Project Number: SP2019-045
Project Name: Channel Corp
Project Type: SITE PLAN
Applicant Name: Pross Design Group
Owner Name: Channell Commercial Corp.
Project Description: Discuss and consider a request by Mark W. Pross of Pross Design Group, Inc. on behalf of Alton Frazier of Channell Commercial Corporation for the approval of an amended site plan for an existing industrial building on an 18.762-acre parcel of land identified as Lot 2, Block A, Channell Subdivision Addition, City of Rockwall, Rockwall County, Texas, zoned Light Industrial (LI) District, situated within the SH-205 By-Pass Overlay (SH-205 BY OV) District, addressed as 1700 John King Boulevard, and take any action necessary.

Project Number SP2019-045	Owner Channell Commercial Corp.	Applied 11/18/2019	DG
Project Name Channell Corporation	Applicant Pross Design Group	Approved	
Type SITE PLAN		Closed	
Subtype AMENDING		Expired	
Status P&Z HEARING		Status 11/22/2019	DG

TO: Planning and Zoning Commission
FROM: David Gonzales, *Planning and Zoning Manager*
DATE: December 10, 2019
SUBJECT: SP2019-045; *Amended Site Plan for an Existing Manufacturing Facility (Channell Commercial Corporation)*

job no
 1423
 sheet
 A1.0

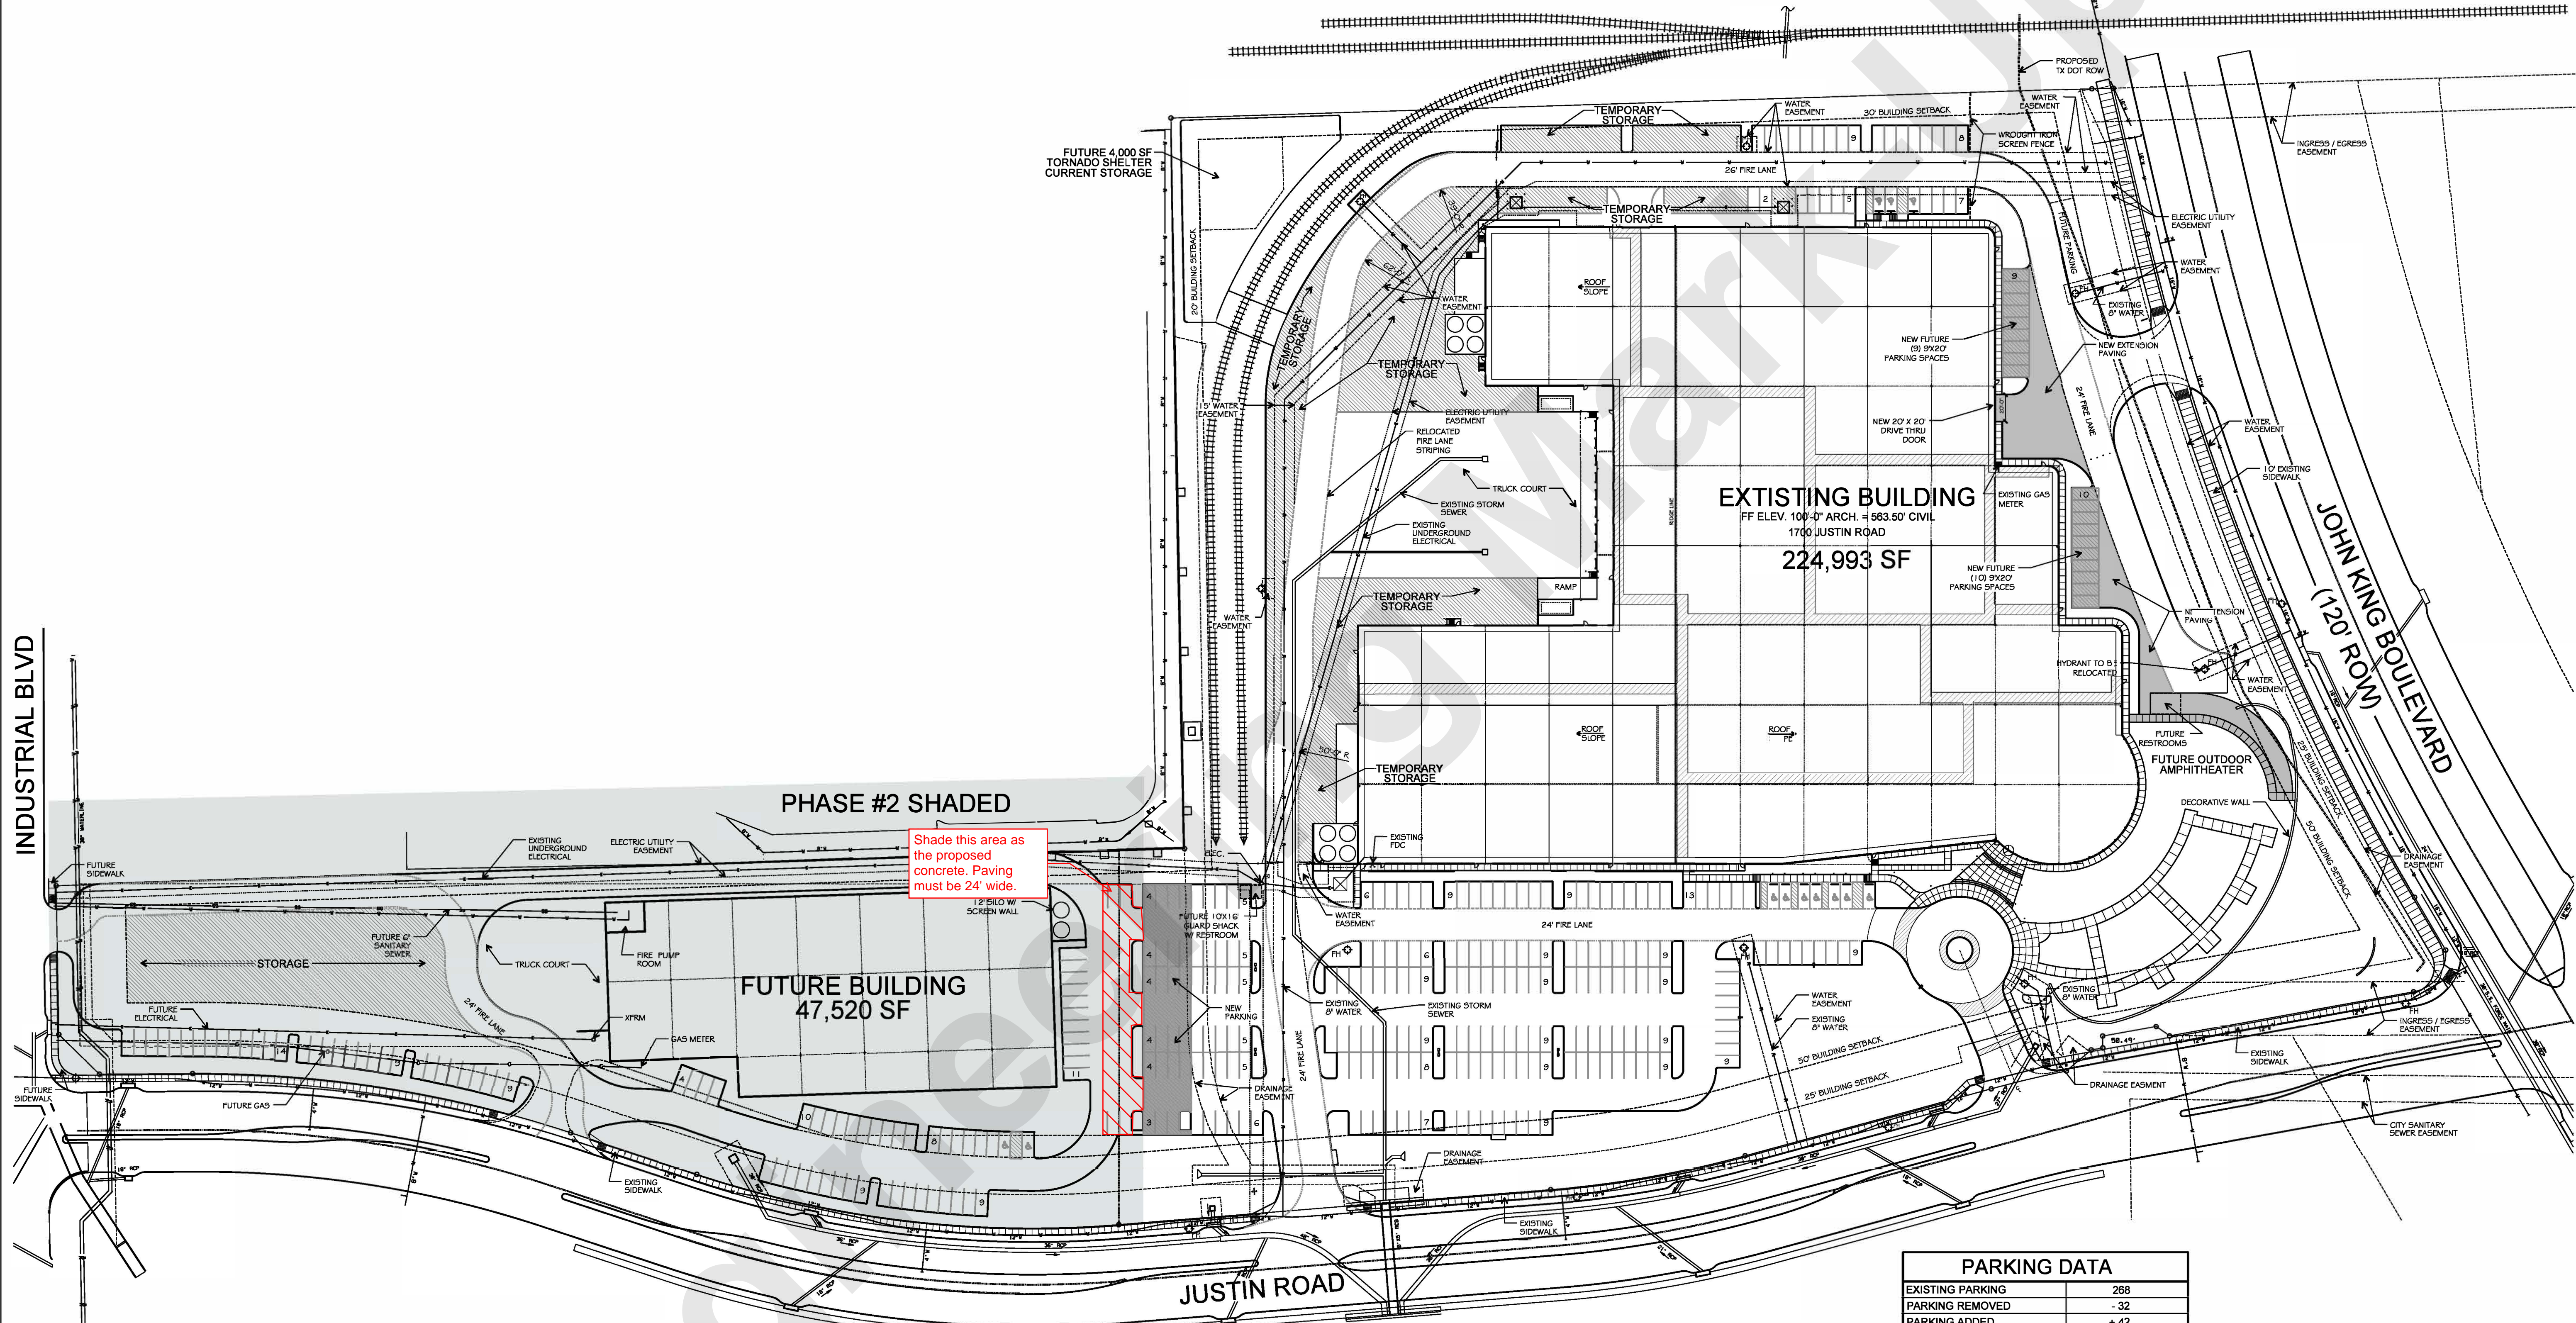
Shade this area as the proposed concrete. Paving must be 24' wide.
